STAFF REPORT: 09/10/2025 MEETING

ADDRESS: 2894-2900 E. GRAND BOULEVARD

APPLICATION NO: HDC2025-00441

SCOPE: REPLACE STOREFRONTS, ERECT STAIRS, REPLACE DOORS, ERECT FENCE

The stairs proposed for replacement were installed sometime between 2022 and 2023. Photo by applicant.

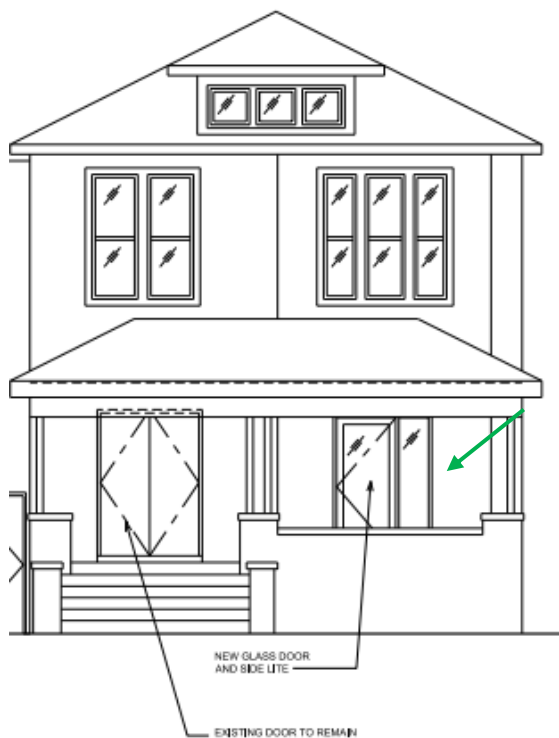
Staff notes the west side wood stairs which were installed without HDC approval are proposed to be removed and replaced in the current application. Also, the applicant has stated that they would like to maintain the current fencing as is. Staff did provide the applicant the opportunity to add the remaining item/the recladding of 2894 W. Grand Boulevard's front facade to the current submission, but he noted that the owner would like to address the work at a future date. Please note that any outstanding unapproved items will remain as violations which are subject to future enforcement by the building department.

2898 E. Grand, proposed elevation. Green arrow indicates new door and sidelite.

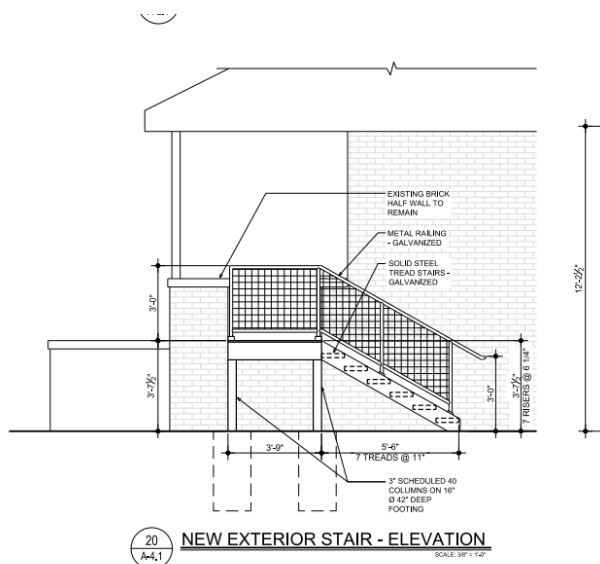
- It is staff's opinion that the new doorway proposed for the 2898 E. Grand façade does not meet the Standards (see below elevation). See the below Google Streetview image of the building, taken in 2007 to note conditions prior to the current overgrown vegetation's coverage of the front wall and porch. The applicant has noted that the new door will be located where a former window opening has been bricked in. The National Park Service's Guidelines for Rehabilitating Historic Buildings [rehabilitation-guidelines-1997.pdf](https://www.nps.gov/tps/plan-manage/rehabilitation-guidelines-1997.pdf) recommends the following for new entrances:
 - Designing and installing additional entrances...for a the new use in a manner that preserves the historic character of the buildings, i.e., limiting such alterations to non-character-defining elevations.

Although the property now houses a commercial use, it still does maintain its original residential character, with the south/front façade remaining as a character-defining elevation. While it is common for houses of this vintage and plan to serve as a multiple-family dwelling with two entry doors at the front façade, the building originally served as a single-family dwelling, with a single entrance at the façade. The addition of a second entrance/enlarging a former window opening would detract from its historic character. Also, the proposed door and sidelite style is commercial in nature/is incompatible with the residential character of the building. Staff therefore recommends a denial of this scope item because the location of a new

door at the façade does not meet the above-quoted guideline and the proposed new door is incompatible with the building's historic character.

- The doorway proposed for 2898 E. Grand's façade does not meet the Standards as the National Park Service's Guidelines for Rehabilitating Historic Buildings limit such alterations to non-character-defining elevations. Also, the proposed door and sidelite style is commercial in nature/is incompatible with the residential character of the building.
- The material for the new door at 2894 E Grand Boulevard's west side wall has not been provided

Recommendation 1 of 2, Denial – At 2898 E. Grand, install a new door and sidelite at the front/south façade

- The new door and sidelite proposed for 2898 E. Grand is proposed for installation at the building's primary/front, character-defining façade
- The style of the new door and sidelite/doorway proposed for installation at 2898 E. Grand Blvd's façade is commercial in nature/is incompatible with the residential character of the building.

2898 E. Grand Boulevard, 2015 Google Streetview image which shows the building free of vegetation. Yellow area indicated the proposed location of the new door and sidelite while the red arrow indicates the proposed location of the patio wall enclosure and new metal staircase.

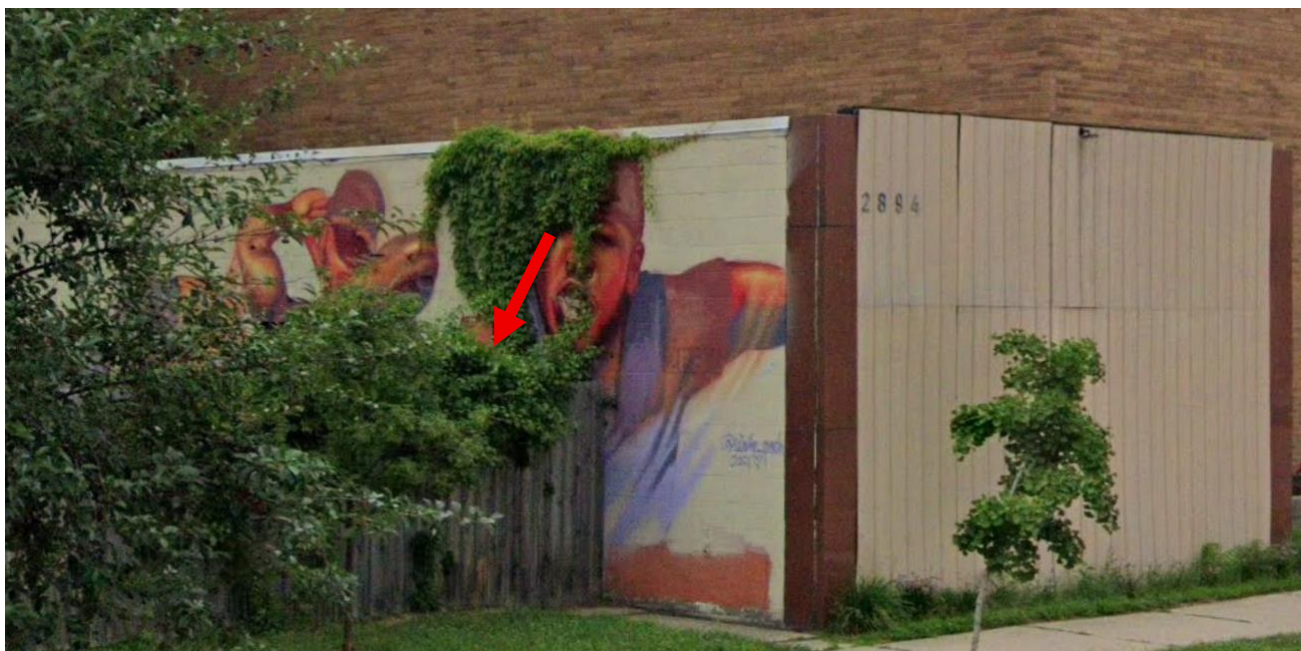
- It is staff's opinion that the new metal staircase proposed for 2898 E. Grand Blvd.'s front porch does meet the Standards as it is a reasonable alteration within the context of the adaptive reuse of this building and the surrounding long-time commercial context commercial of this block of East Grand Boulevard and it will have less of an impact on the building's historic character than the proposed entrance alteration (see below elevation drawing)
